Plan Commission

Agenda

Monday, April 22, 2019

6. Recommendation regarding a Site Plan for a new building and parking garage called De Pere Brick Yard at 1091 N. Broadway Street (Parcel ED-1128-E-1-3). Submitted by Dave Hongisto, SISU Properties LLC, authorized representative for Nulund Group II LLC, property owner.

C SILT FENCE

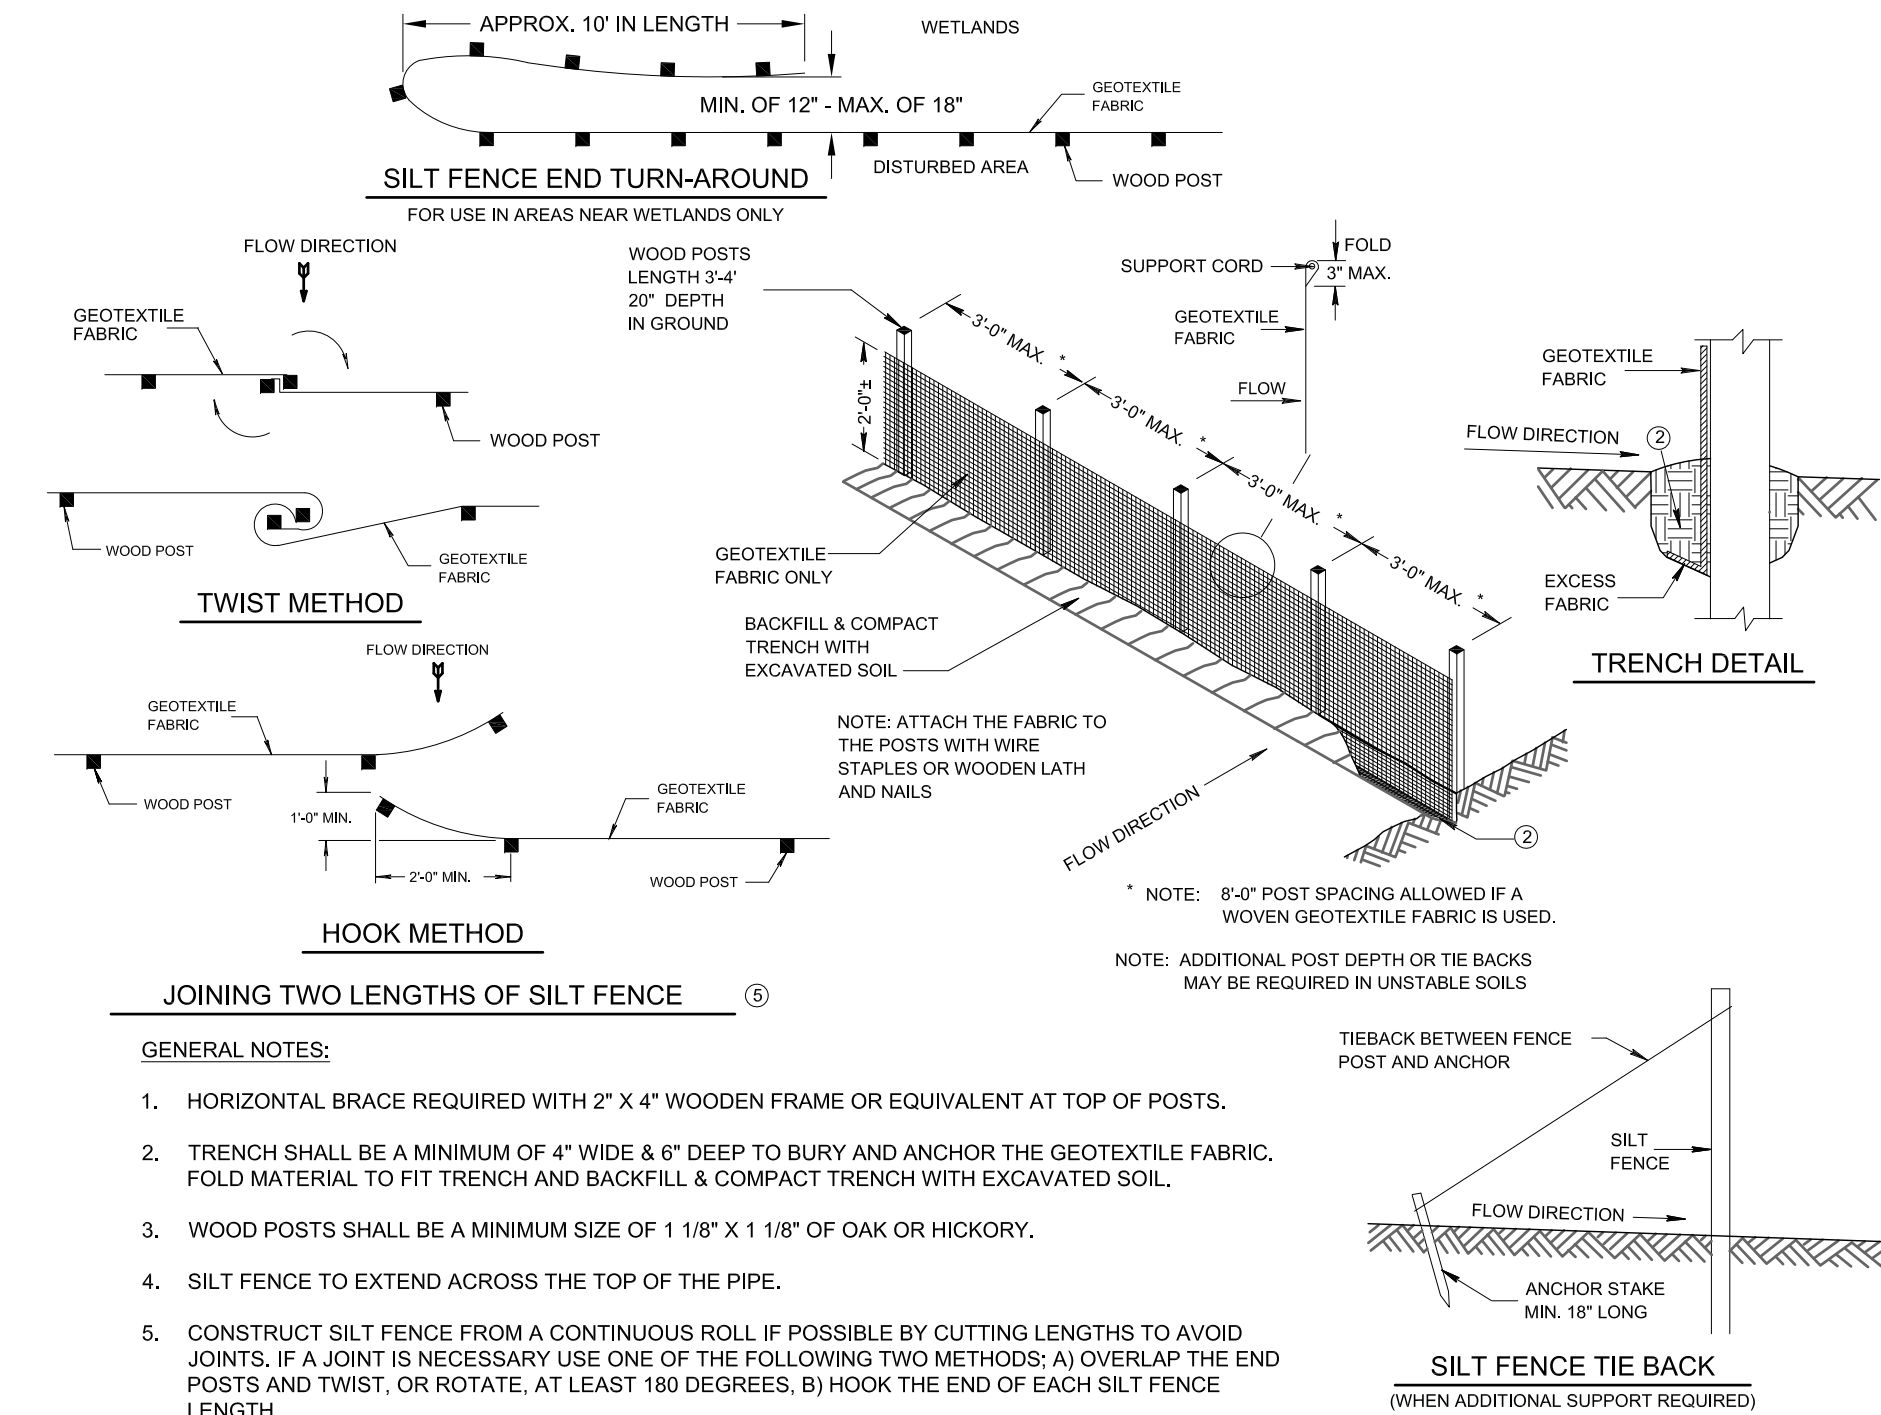
13. Sheet C5.0 - Need to show material stockpiling locations with erosion control protection.
14. Sheet C6.0 - Detail B Comment 3: Sidewalk width is 5.0 feet per City standards. As referenced on sheet C2.0.

REVISION DESCRIPTION
NO.	DATE	DRAFTED BY	CHECKED BY	PROJECT NO.	
	APRIL 8, 2019	RPH	MCL	1569-01-18	
				DRAWING NUMBER	
				SHEET NUMBER	
				C6.0	
				OF 9

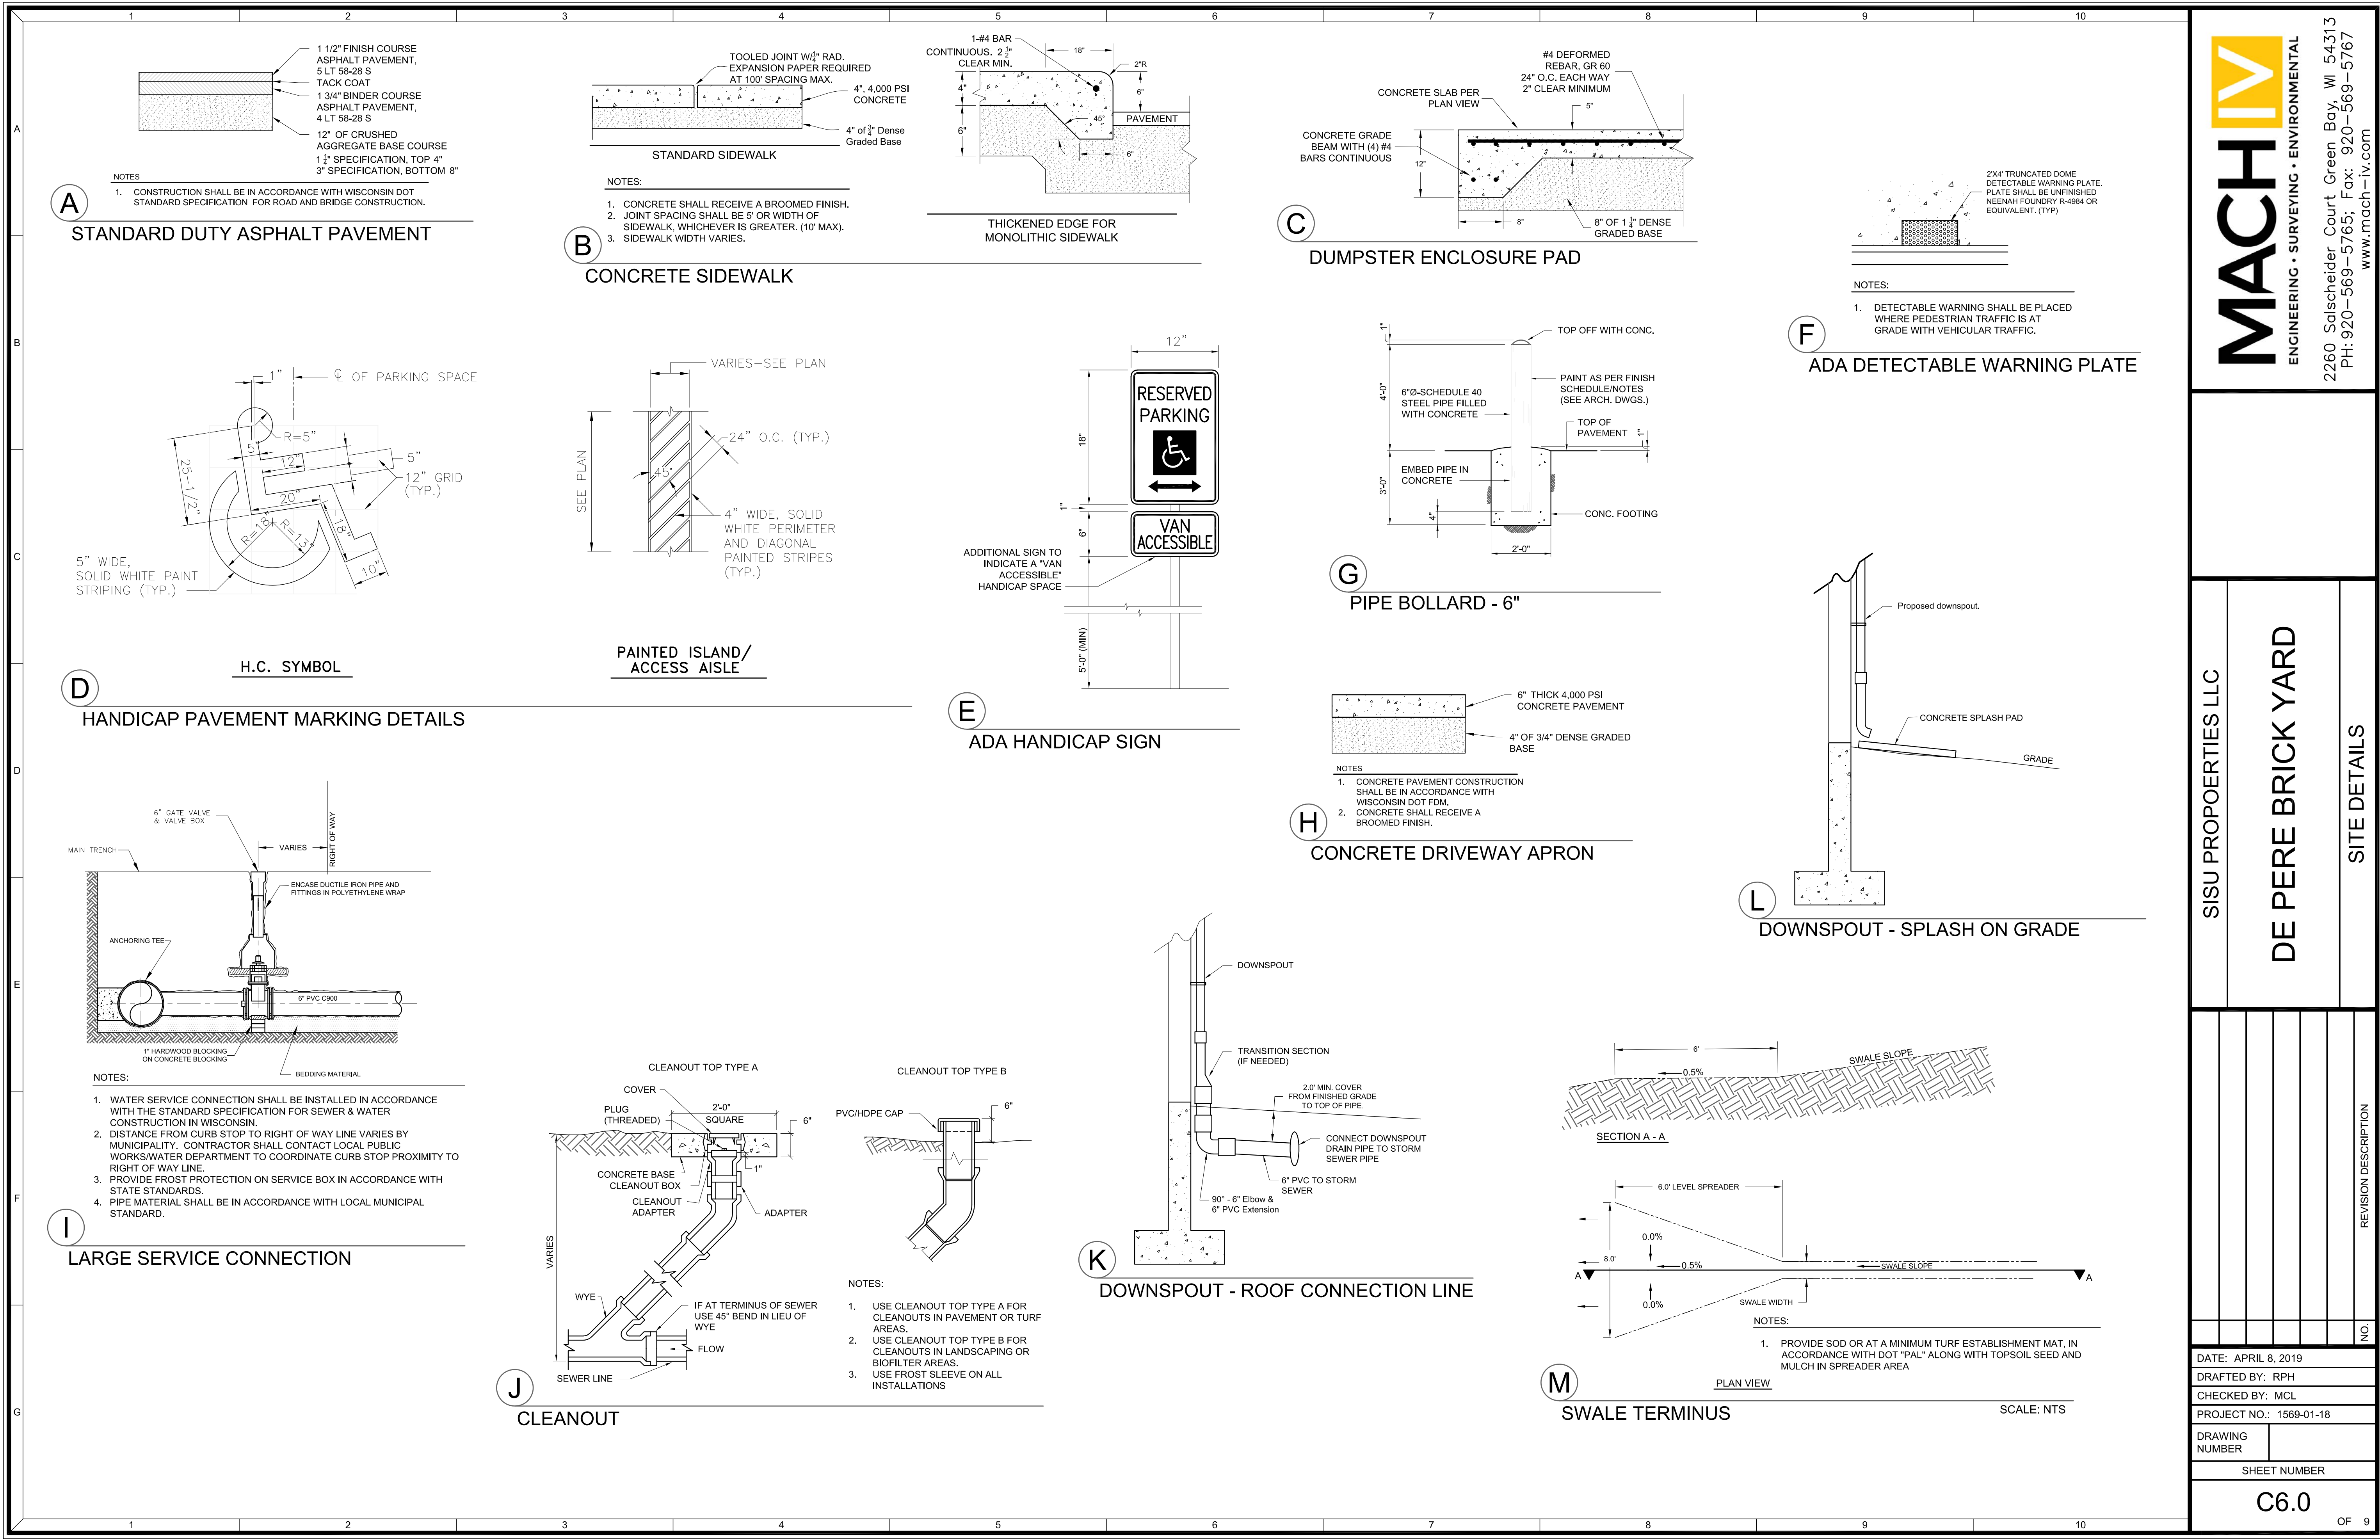
15. Sheet C6.0 - Detail I can be deleted as the City will provide water service to the property line. Contractor will only need to connect to the back side of the valve (agreement pending).
